| Model | | NA2 (European & Taiwan versions only) | | | | | Volt/Hz | | Date of Modification | | Serial Number | | | |
| Modified Article | | | | | | | | | | | | | | |
| Reason for Modification | | To prevent thin white lines | | | | | | | | | | | | |

DETAILS OF MODIFICATION

Drawing No. 1

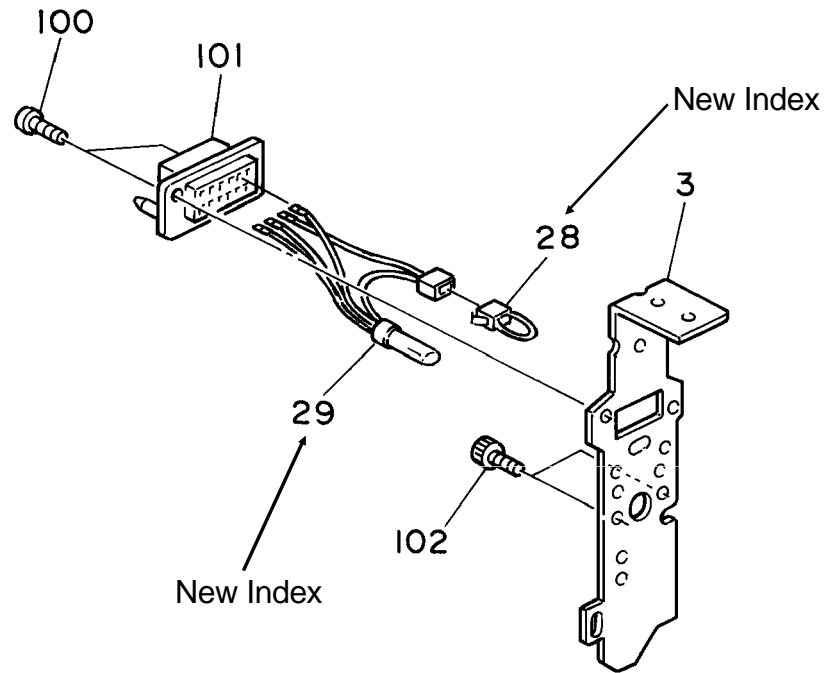
1. Add two parts and index numbers in the illustration as shown in Drawing No.1

| NRG/Ricoh | Index | Part Number | Description | Q'ty |
|-----------|-------|-------------|--|-----------------------|
| Common | * 28 | C5288173 | Short Connector - A4/LT Color Indication | 1 (See Drawing No. 1) |
| Common | * 29 | C5288172 | Relay Harness - A4/LT Drum | 1 (See Drawing No. 1) |

Drawing No. 2 (Page 62)

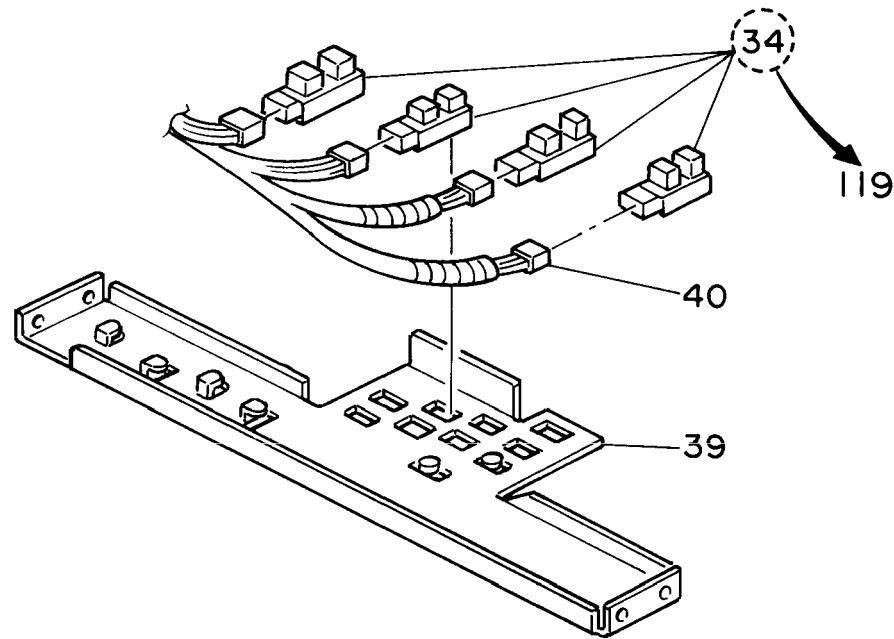
1. Correct a index number in the illustration as shown in Drawing No. 2.

| NRG/Ricoh | Index | Part Number | Description |
|-----------|-------|-------------|--------------------------------------|
| NRG | * 119 | 14030690 | Photointerrupter (See Drawing No. 2) |

Drawing No. 3 (Page 82)

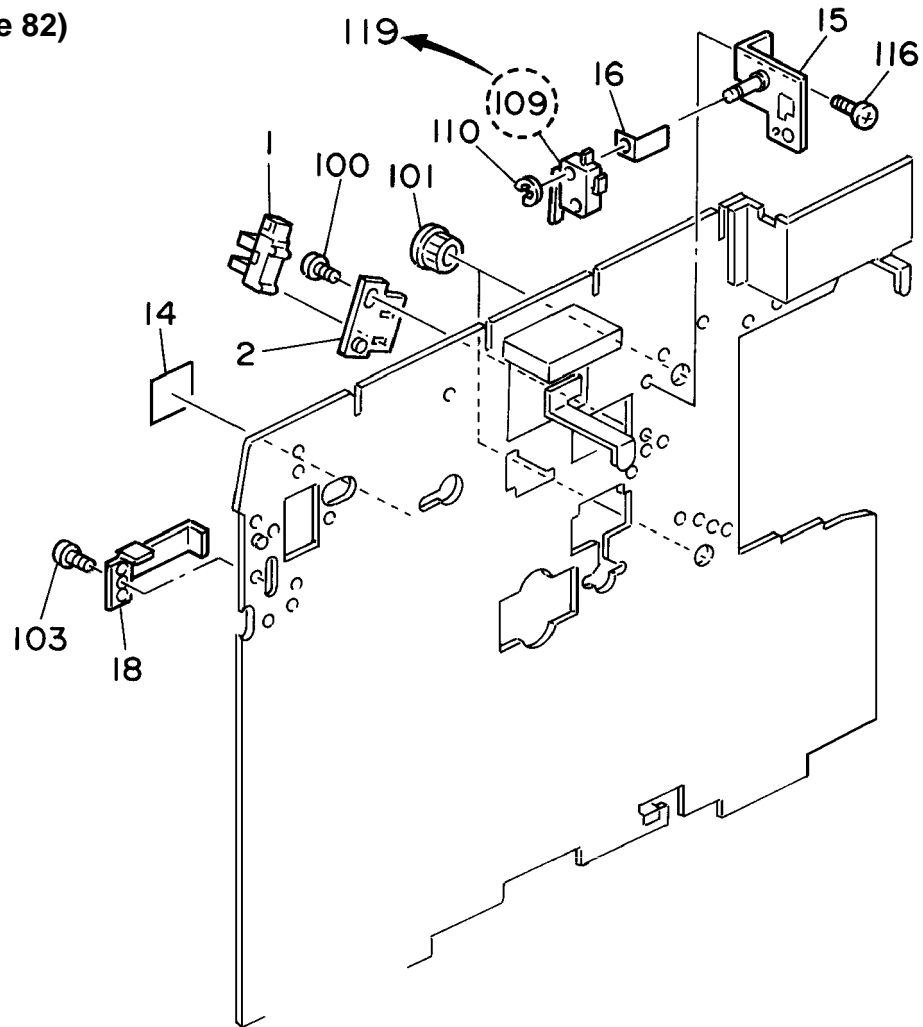
1. Correct a index number in the illustration as shown in Drawing No. 3. (NRG version only)

| NRG/Ricoh | Index | Part Number | Description |
|-----------|-------|-------------|--|
| NRG | * 119 | 12041442 | Microswitch (For all version machines) |

See Drawing No. 3

Drawing No. 4 (Page 84)

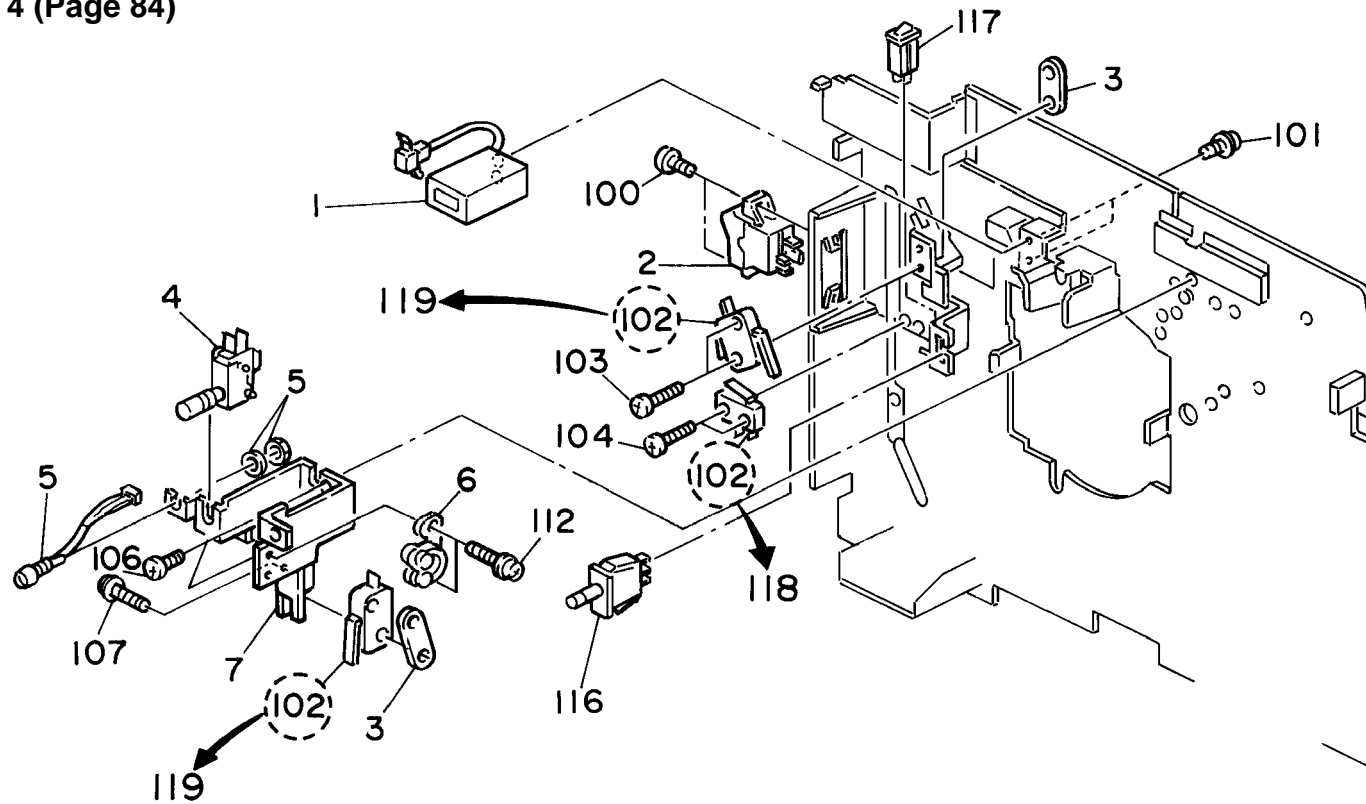
1. Correct index numbers in the illustration as shown in Drawing No. 4.

* : New Index (See Drawing No. 4)

[Page 108 in the parts catalog]

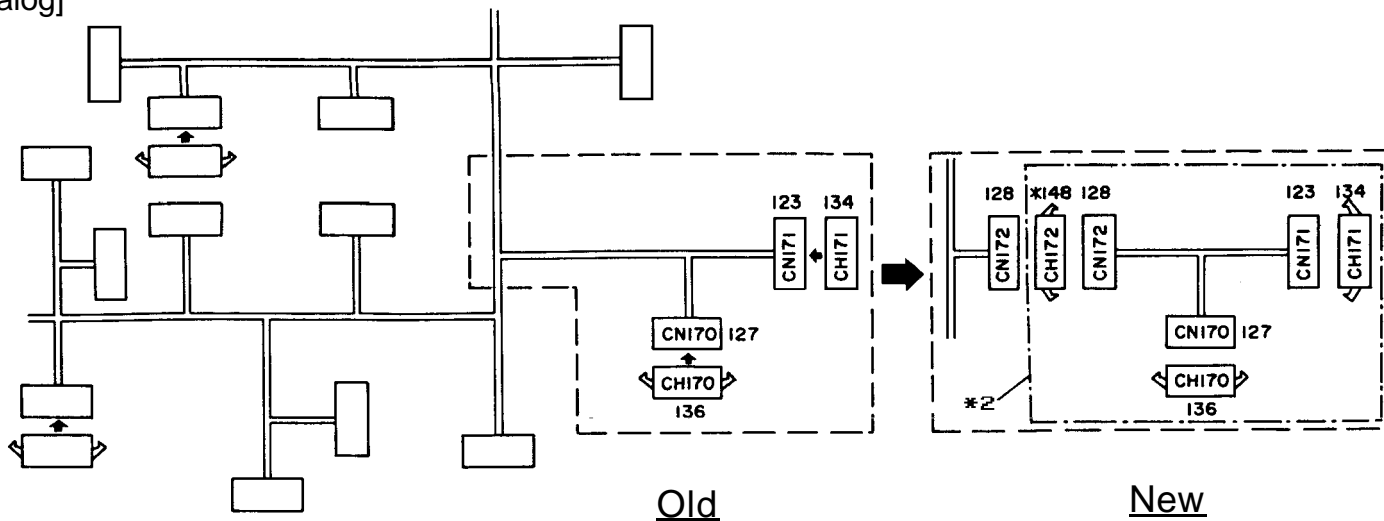
When removing the paper feed front plate, it is necessary to disconnect two harness for the paper return motor and separation plate pressure release solenoid. To facilitate servicing at that time, the DC drive harness has been changed. Now the connector (CN172) can be disconnected near the paper feed front plate.

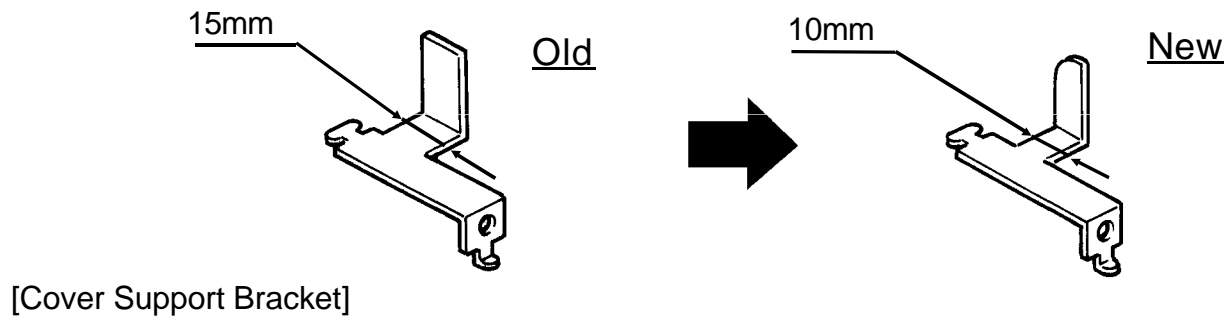
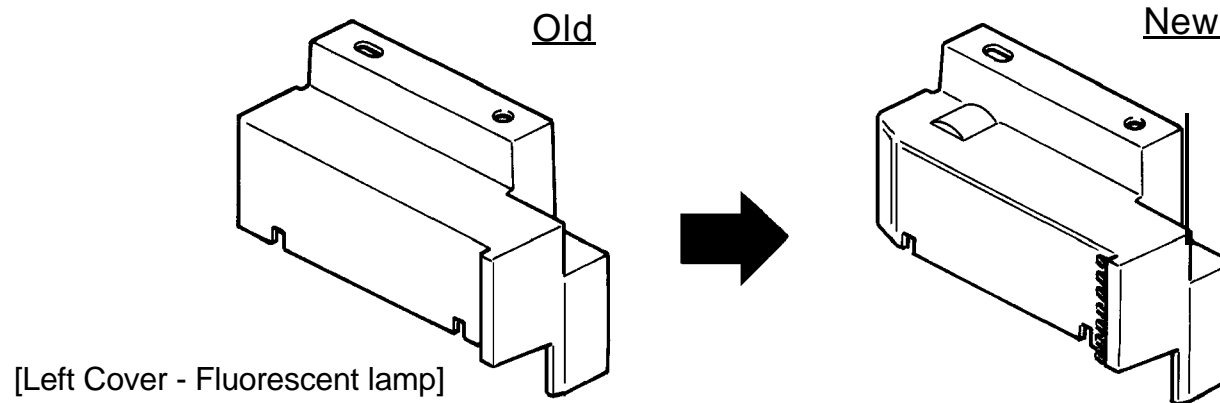
The left and right fluorescent lamp covers have been changed so that an operator can grip them easily when opening the scanner unit. For the right cover, the improvement is minor and the part number has not been changed (# C2103219 for NRG USA/TAIWAN version, # C2103220 for NRG European version, # C2103223 for Ricoh version). However, the left fluorescent lamp cover has to be replaced with the cover support bracket (# C2093169) at the same time, so its part number has been changed as described on the first page.

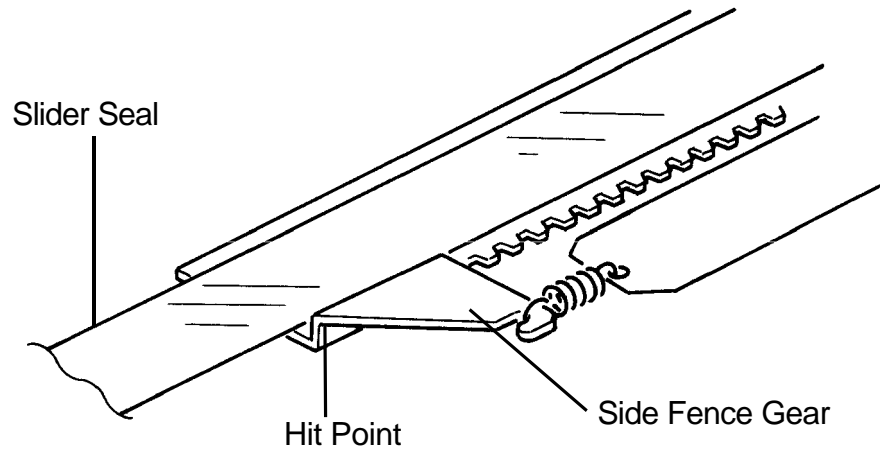
When an operator moves the original side guides to adjust them to the original width, the slider seals (mylar strips : C2093093) tend to be caught by the edge of the side fence gears (See figure). This may cause the operation of the original side guides to be hard.

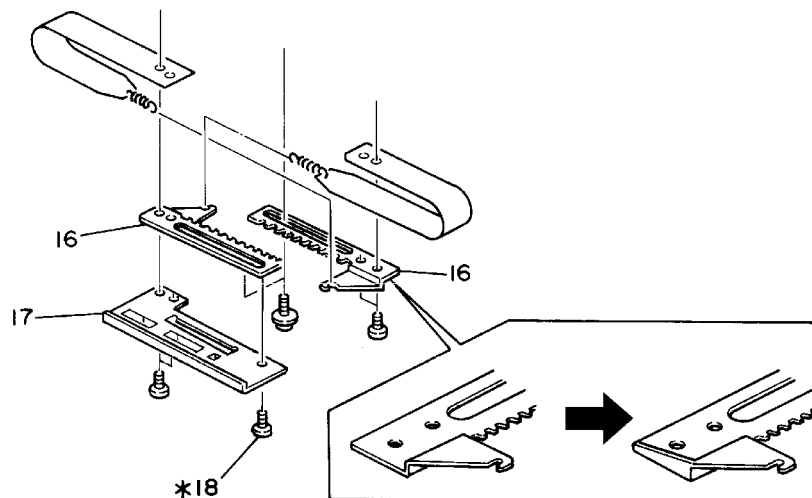
To make the original guides move smoother, the shape of the side fence gears has been changed as shown in the below figure. At the same time, the sensor shielding plate (Index 17) has been secured with the side fence gears by a screw (Index 18) in order to remove play.

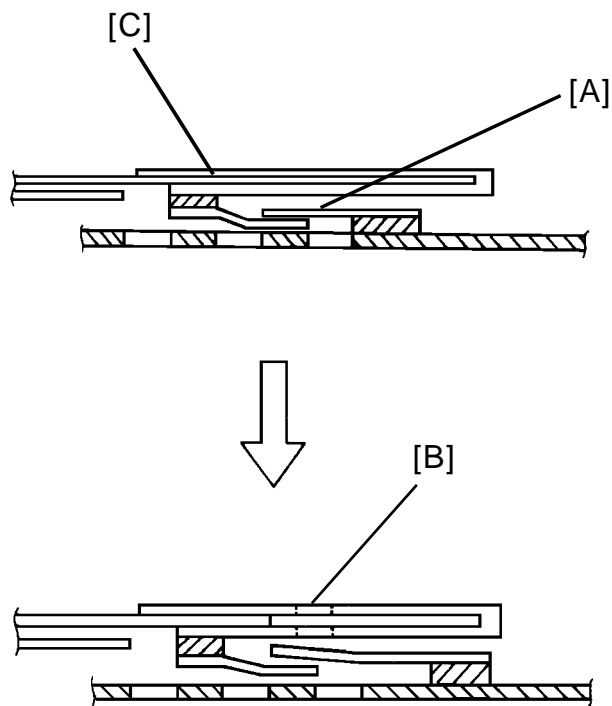
To facilitate assembling, the length and sticking position of the metal screen mylar [A] has been changed as shown in the illustration below. Also two holes [B] are made on the vinyl part of the tetron screen [C] so that customer engineers can confirm through the holes if the mylar is set correctly.

The part number of the metal screen mylar has been changed but the part number of the tetron screen has not been changed.

Illustration 1

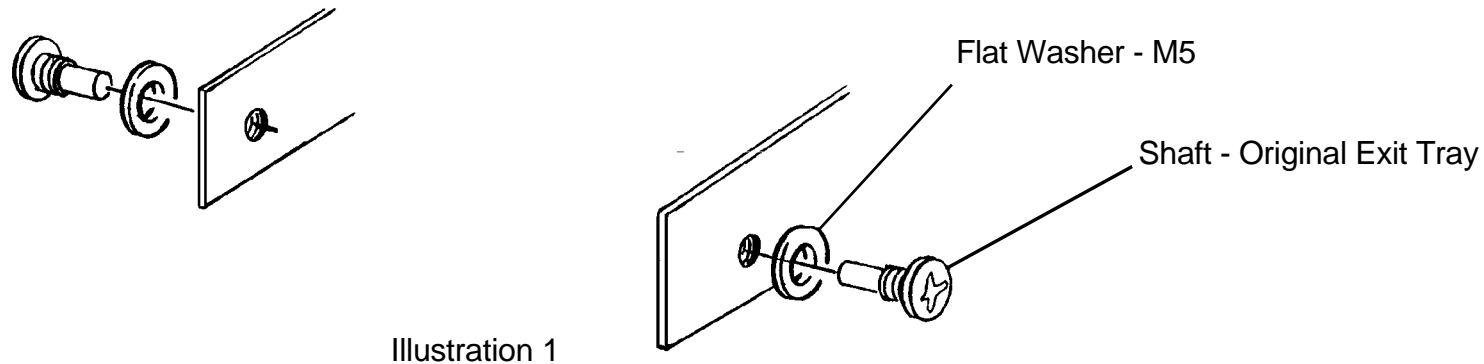
To prevent the original tray fixing nut from becoming loose, original tray shafts have been modified . Screw holes are made on the side plates and the shafts are screwed tightly with the washer in the factory. (illustration 1.)

Illustration 2

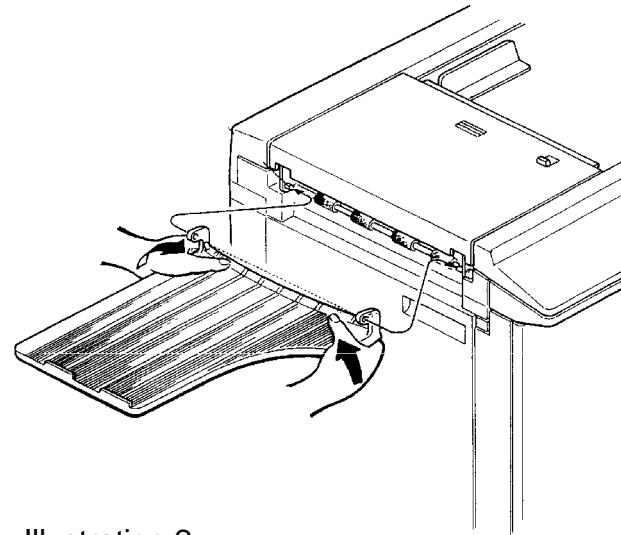
Due to this modification, installation procedure has been changed. To install, bend in the original exit tray slightly, placing the shaft through the holes provided on the original tray as in illustration 2.

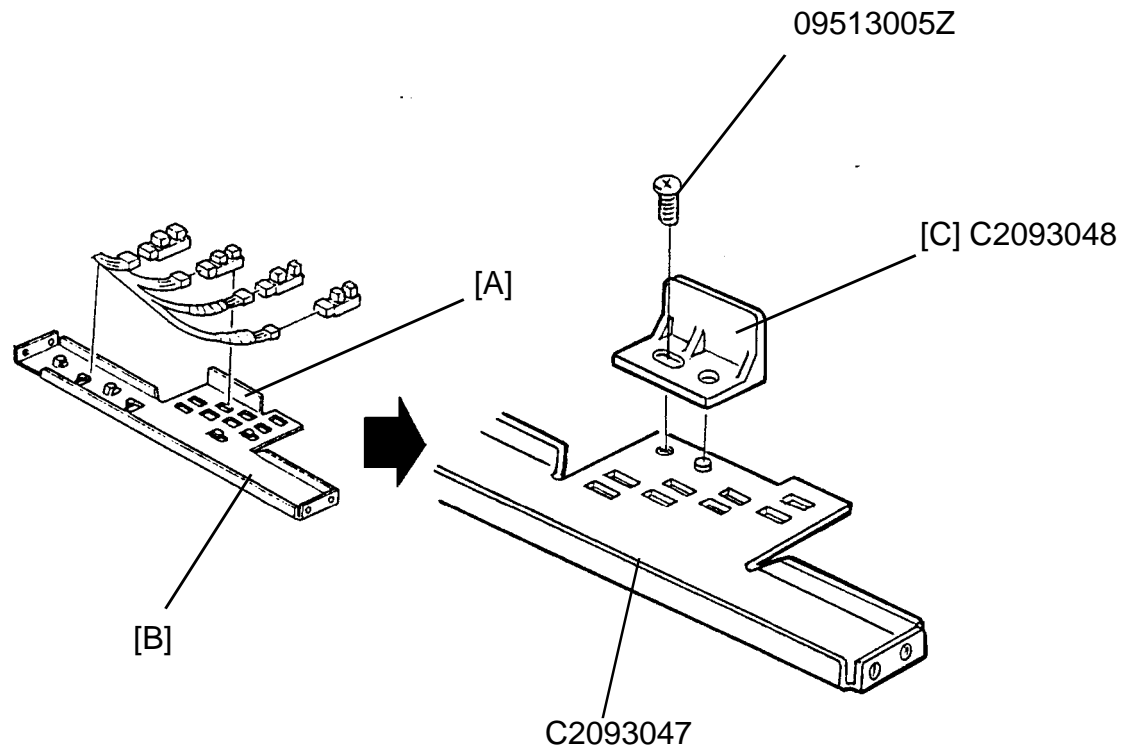
Part [A] of the sensor scanner bracket [B] supporting the sensor shield plate has been changed from a metal to a plastic one [C]. When the sensor shield plate was moved, it rubbed the sensor scanner bracket and metal powder was made. This sometimes dropped on the A/D conversion PCB.

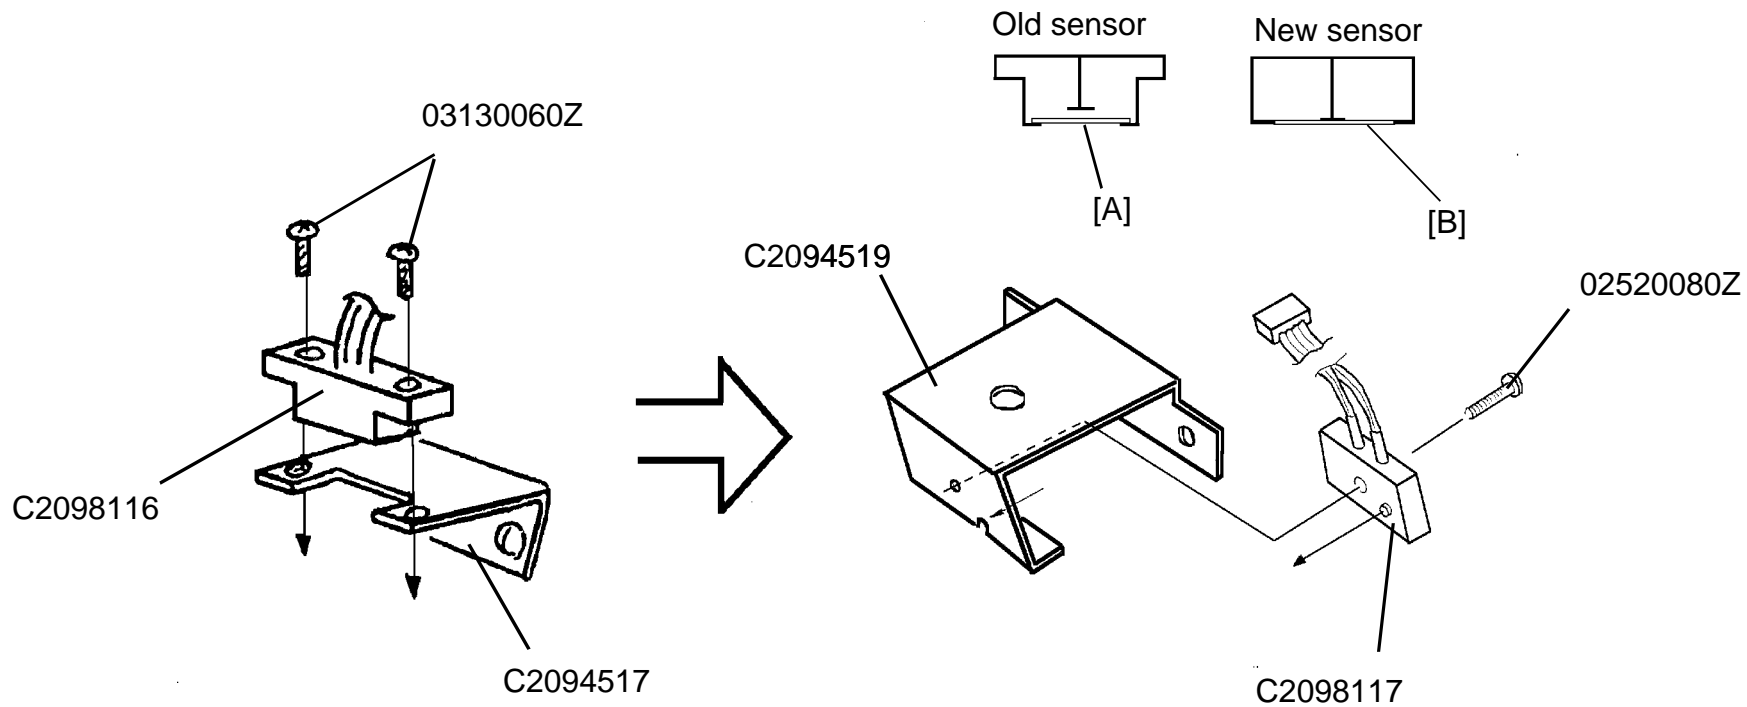
It is sometimes reported that the drum master detection sensor does not detect the master on the drum. This problem happened when the filter [A] was out of position. To prevent this, the drum master detection sensor has been modified. The filter [B] of the new sensor is fixed in position.

Due to this modification, the shape of the drum sensor bracket has also been changed as shown in the illustration.

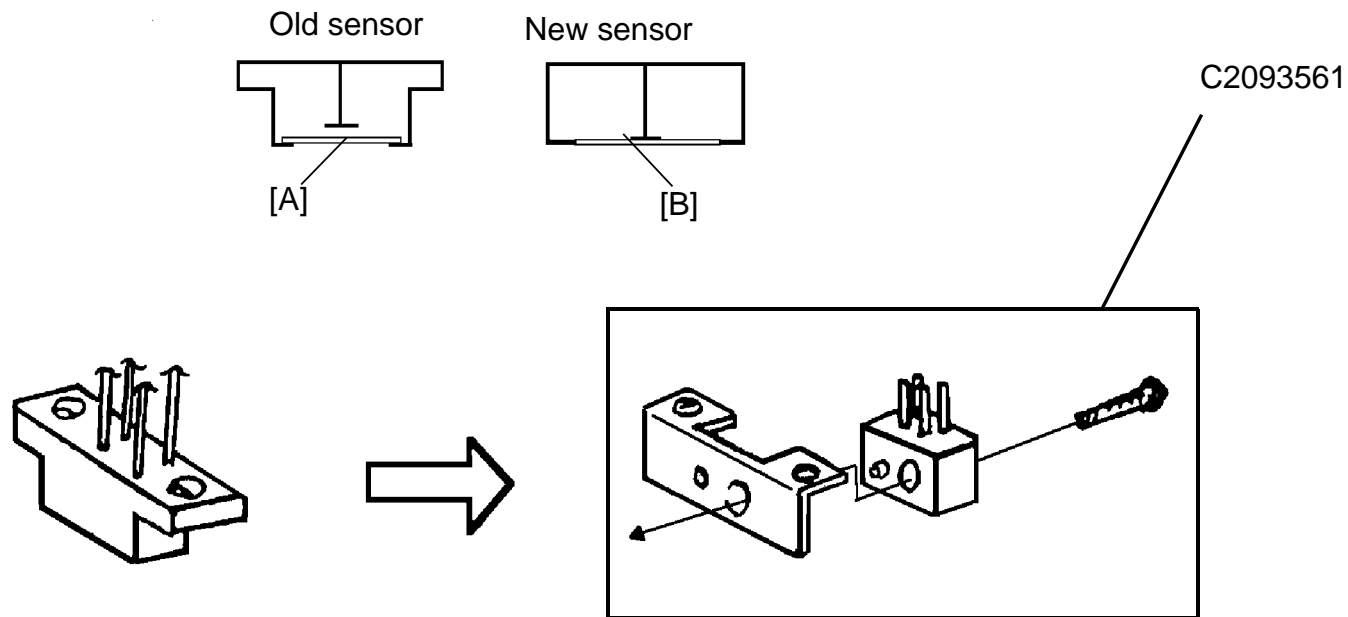
It is sometimes reported that the master eject sensor does not detect the ejected master. This problem happened when the filter [A] was out of position. To prevent this, the drum master detection sensor has been modified. The filter [B] of the new sensor is fixed in position.

The new part C2093561 consists of a photosensor, a bracket and a screw. They are supplied as an assembly.

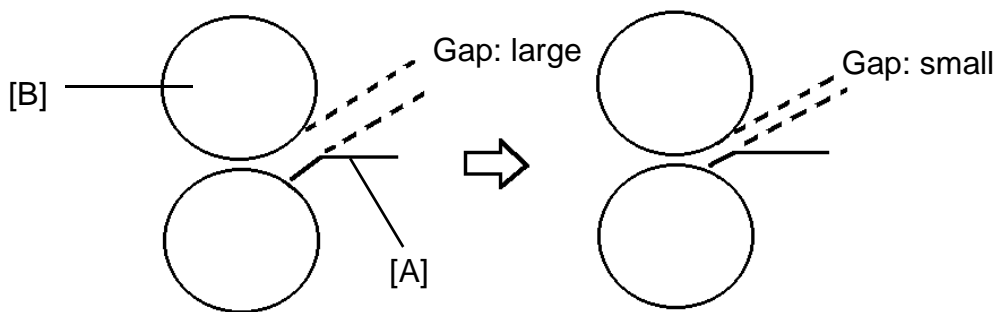
If a machine is used under high temperature and high humidity conditions, the leading edge of the master tends to curl, and sometimes master misfeed might occur. To minimize master feed jams, the shape of the master guide plate [A] has been changed to reduce the gap between the plate and the upper master feed roller [B].
